RE: MODIFICATION OF CENTRAL PARK CONCEPT PLAN (MP06_0171 MOD 16) AND BLOCK 4B CENTRAL PARK ADAPTIVE REUSE (SSD 9374) – RESPONSE TO SUBMISSIONS

Table 1 – Response to heritage matters

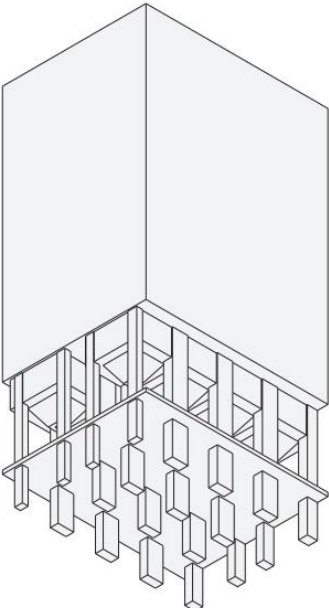
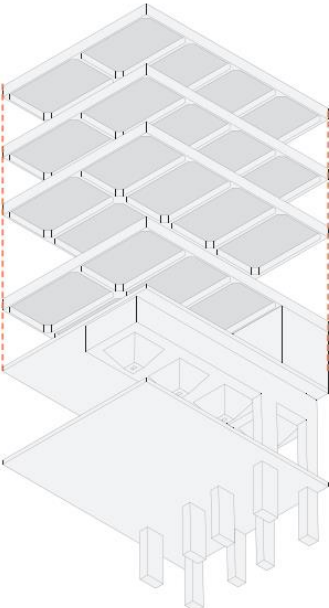
Item	Discussion
<u>City of Sydney Council</u>	
1.1) Rooftop Addition The proposed roof addition provides for an additional 2 floors. The addition is distinct from the original masonry form of the building, it comprises glazing and	1.1) The proposed rooftop addition has been designed in such a way to mitigate visual impacts. through its considered built form. The addition is partly obscured behind the parapet and the form of the upper floor addition is modulated with a splayed roof form to protect principal views from the south to the principal southern and eastern elevations. Setbacks to the east and west

Item	Discussion
<p>metal materiality to distinguish. Its construction requires the removal of the existing gabled truss roof and one of the two towers. The additional floors will be apparent in views from the north towards the northern elevation of Building 22/23. Its form is supported but the impact on heritage fabric is high. The form does not draw an objection from the City but notes the impact on the heritage significance of the site is high.</p>	<p>of the addition similarly protect these views and ensure that the addition is obscured by the parapeted facades. Critically, the City’s response acknowledges that the form of the addition is supported and does not draw an objection.</p> <p>Materiality has been designed to distinguish between the old and new and to have regard to the architectural language and character of the triggen plant/ cooling towers. The materiality also complements the industrial character of the original Brewery buildings and therefore is considered appropriate. This approach has been taken with all of the proposed additions.</p> <p>The proposal provides for an additional 2 floors allowing additional required floor space to make this adaptive re-use project financially and practically feasible. As detailed in the Heritage Impact Statement, removal of the existing gabled truss roof is unavoidable to facilitate this outcome, however this is mitigated by the retention and conservation of the gabled truss roof at Building 26. Overall the proposed addition is considered reasonable with consideration for the facilitation of future occupiable space, and the design efforts taken to mitigate visual impacts and to comply with the intent of the Stage 1 design. The new level will also include heritage interpretation zones where retained elements will be placed on display.</p>
